BHP Mitsubishi Alliance

Supplementary information in response to IESC
comment

To: Hannah Silcox
From: Scott Weeks, Dave Western
Company: BMA
SLR Consulting Australia
cc:
Date: 8 October 2025
Project No. 620. 040484.00002
RE: Saraji Mine Grevillea Pit Continuation Project – Groundwater Impact Assessment IESC Advice Response

PREDICTED MOVEMENT OF PARTICLES

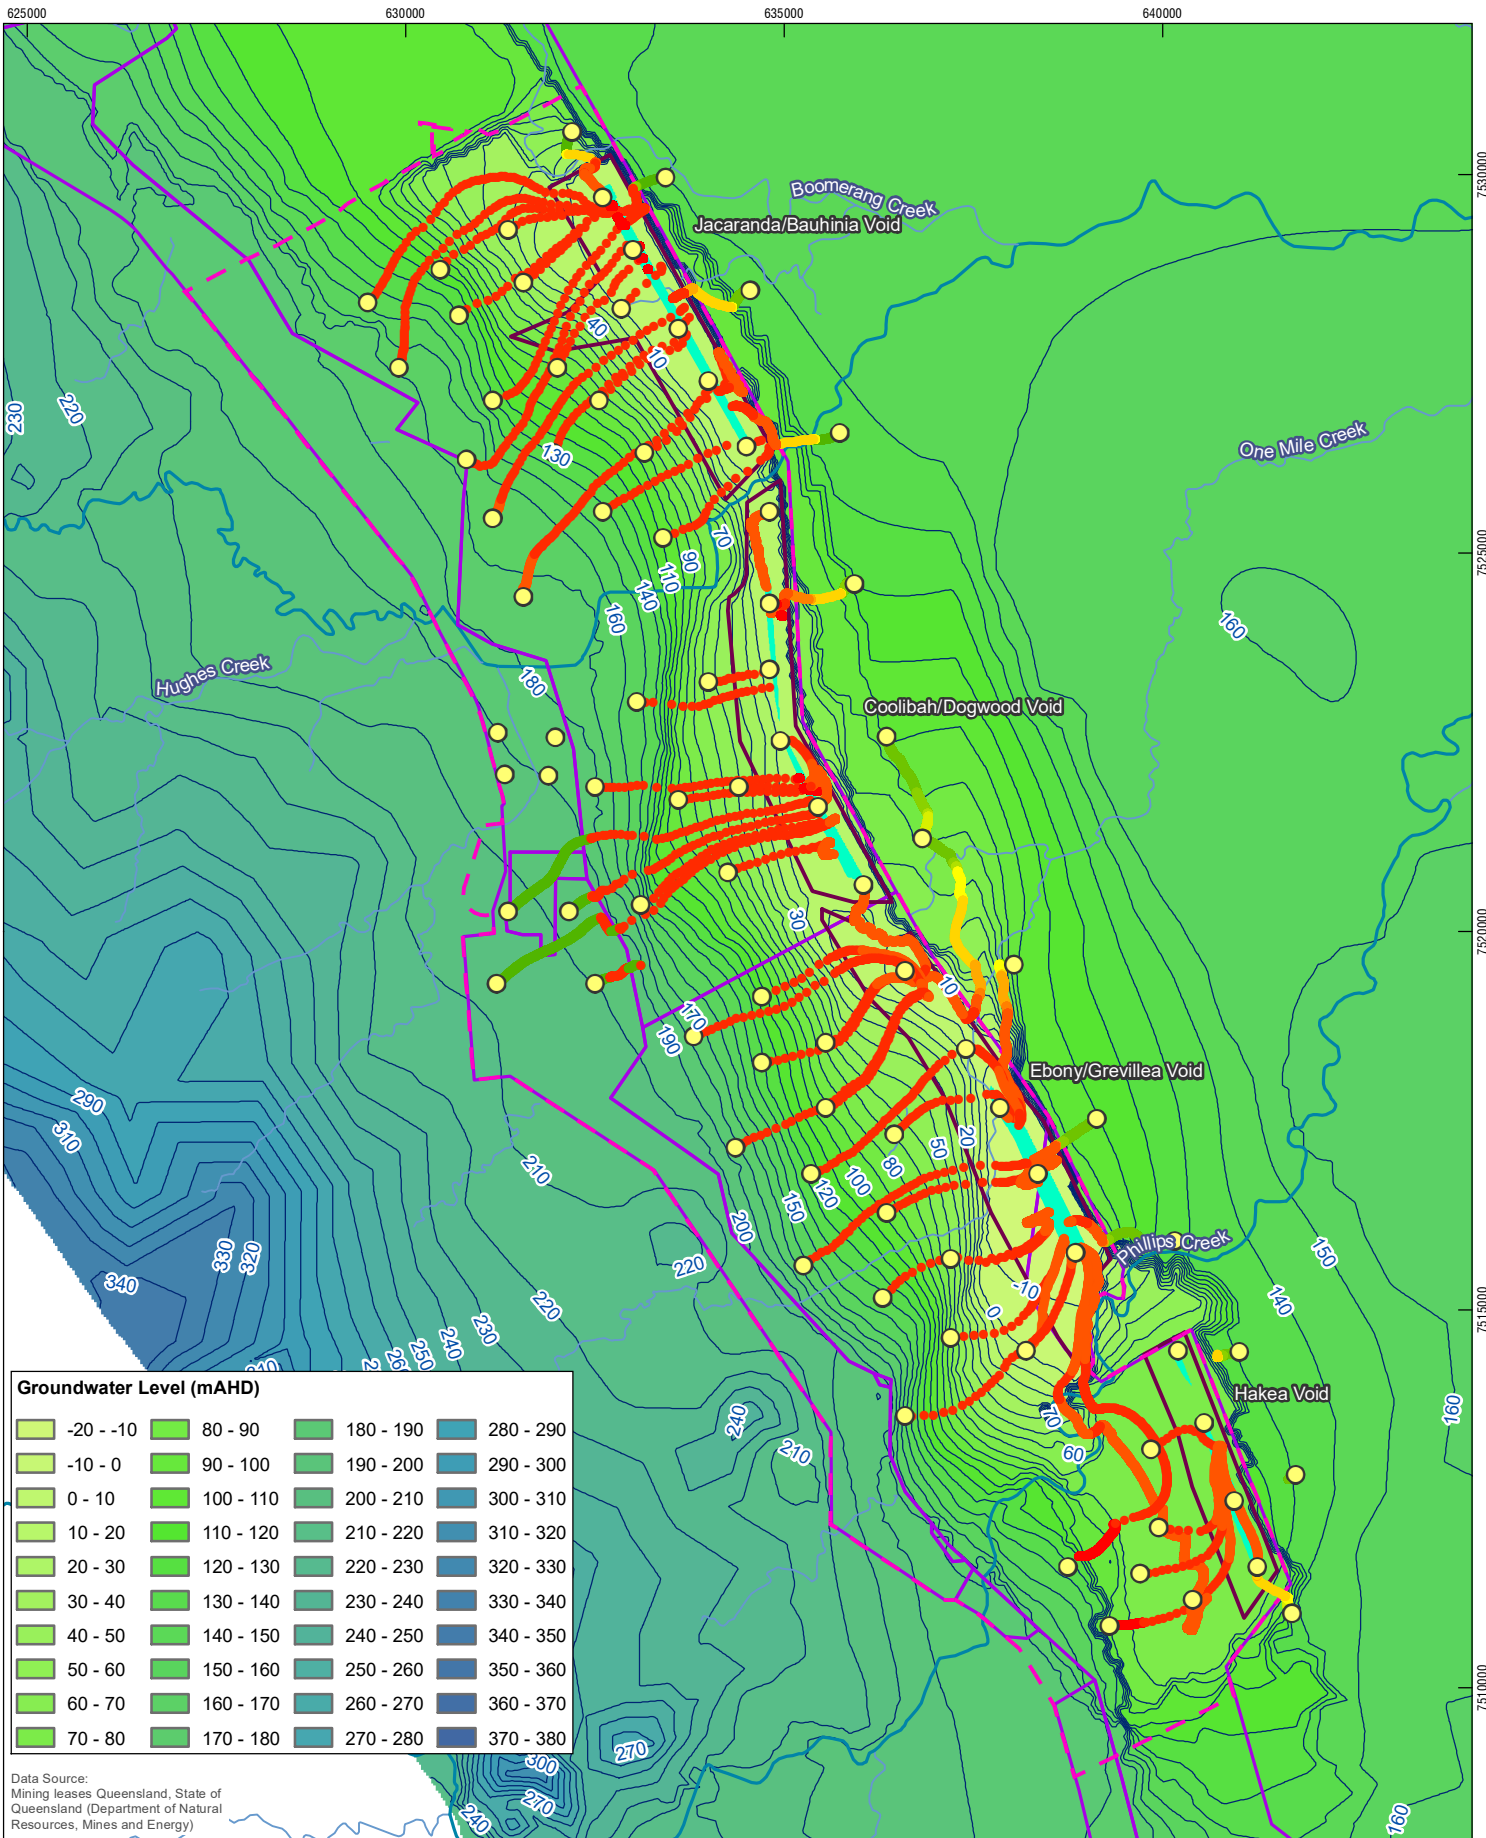
Additional groundwater modelling should estimate and clearly document the long-term impacts of the proposed final void and the increased recharge of spoils.

Particle tracking simulations were undertaken to assess the fate and transport of water through the groundwater system post-mining. **Figure 20** shows the predicted movement of water particles in the 2249 year recovery simulation.

The colour changes along the paths on **Figure 20** indicate that particles situated within the shallower saturated layers at the beginning of the post-mining simulation generally move progressively toward deeper layers representing the Permian coal measures (or backfilled spoil where the coal measures has been mined out). The flow path analysis indicates the particles generally move toward the void lakes, with many of the particles captured in the voids. Some particles starting in the area of the void lakes themselves initially move outwards from the lakes before turning to flow inwards back into the lakes, with the flow path terminating in the lakes themselves, i.e. these particles are re-captured by the voids. Some particles located just east of the SRM area are shown to initially move marginally outwards by less than 500 m in shallow layers before turning to flow back inwards towards the SRM area in deeper layers. Given these particles starting locations are east of the SRM area away from any SRM related potential contamination source, and head gradients remain towards the voids as shown in **Figure 20**, these results do not indicate any potential for increased environmental risk. No particles are shown to move significantly away from the SRM area to the broader receiving environment.
